# Access Compliance Report

## Public Rights-of-Way

### (Curb Ramps)

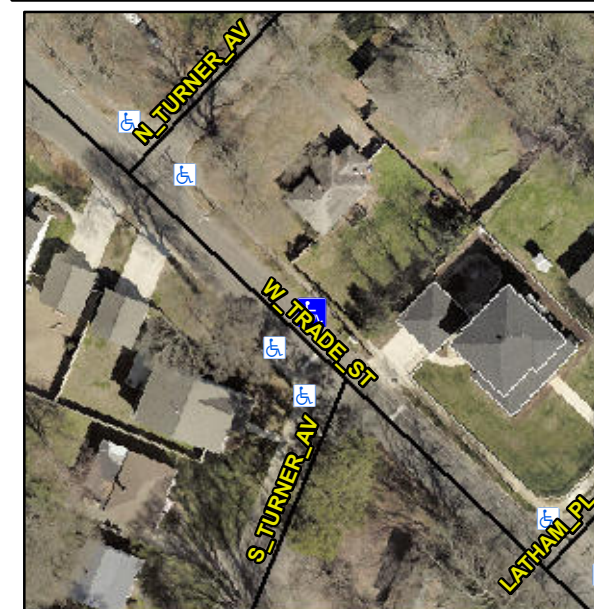
Intersection ID: 9951	Main Street: S_TURNER_AV	Cross Street: W_TRADE_ST	Location:	N
ADA ID: D5AFA24FB217	Ramp Type: Perp	Initial Pass/Fail: Fail	Overall Compliance: No	Severity Score: 26.25
Codes/Mitigation Info/Possible Solution		Field Measurements/Component Compliance

**Not Found, R304.2.2, R304.5.3**

Compliance	Description	Data	Compliance	Description	Data
N/A	Ramp Length (in)	50.0	No	Ramp Slope (%)	15.5
Yes	Ramp Width (in)	48.0	No	Ramp XSlope (%)	3.7
N/A	Flare Type LT	N/A	N/A	Flare Type RT	N/A
N/A	Flare Slope LT (%)	N/A	N/A	Flare Slope RT (%)	N/A
N/A	Flare Traversable LT?	N/A	N/A	Flare Traversable RT?	N/A
N/A	Landing Length (in)	N/A	N/A	DWS Provided?	N/A
N/A	Landing Width (in)	N/A	N/A	DWS Contrast?	N/A
N/A	Landing Slope (%)	N/A	N/A	DWS Length (in)	N/A
N/A	Landing X Slope (%)	N/A	N/A	DWS Full Width?	N/A
N/A	Landing Curb? (Y/N)	N/A	N/A	DWS Offset (in)	N/A
N/A	Shared Landing?	N/A			
N/A	Gutter Ponding?	N/A	N/A	Gutter Slope (%)	N/A
N/A	Gutter Lip Ht (in)	N/A	N/A	Gutter X Slope (%)	N/A
N/A	Painted X Walk1?	No	N/A	Painted X Walk2?	N/A
	X Walk 1 Direction	To SW		X Walk 2 Direction	N/A
N/A	X Walk 1 Width (in)	N/A	N/A	X Walk 2 Width (in)	N/A
	X Walk 1 Slope (%)	1.4		X Walk 2 Slope (%)	N/A
	X Walk 1 X Slope (%)	3.8		X Walk 2 X Slope (%)	N/A

**Remove & Replace Entire Ramp.**
